PLANNING AND ZONING BOARD STAFF REPORT

Delray Ridge Plat

Meeting	File No.	Application Type
October 18, 2021	2020-237-FSP-CCA	Major Subdivision
Applicant	Property Owner	Authorized Agent
Delray Ridge, LLC / Ron Elish	Delray Ridge, LLC / Ron Elish	Allan Hendricks, RLA

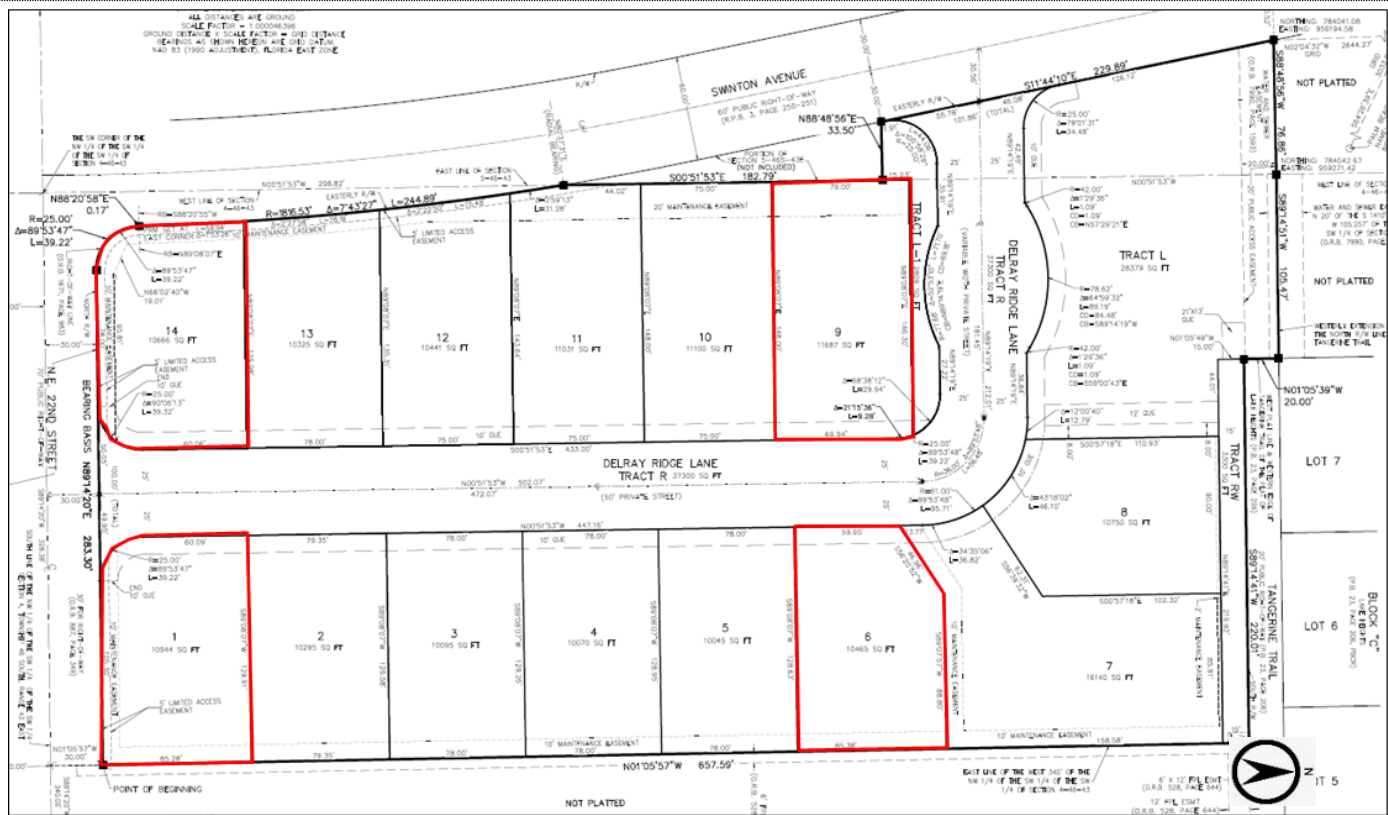
During the technical review of the plat, it was determined that four of the 14 lots (see lots outlined in red, pg. 3) do not meet all of the minimum development standards in LDR Section 4.3.4(K) for R-1-AA zoning. Relief for the reduced dimensions is available via City Commission review at the same time as the consideration of the subject plat.

- Lot Width, Corner Lots: Minimum 95 feet required
 - Lot 1- 85.28 feet provided
 - Lot 9- 79 feet provided
 - Lot 14- 85.28 feet provided
- Lot Frontage, Corner Lots: Minimum 95 feet required
 - Lot 1- 85.28 feet provided
 - Lot 9- 79 feet provided
 - Lot 14- 85.28 feet provided
- Lot Frontage, Interior Lots: Minimum 75 feet required
 - Lot 6- 59.95 feet provided
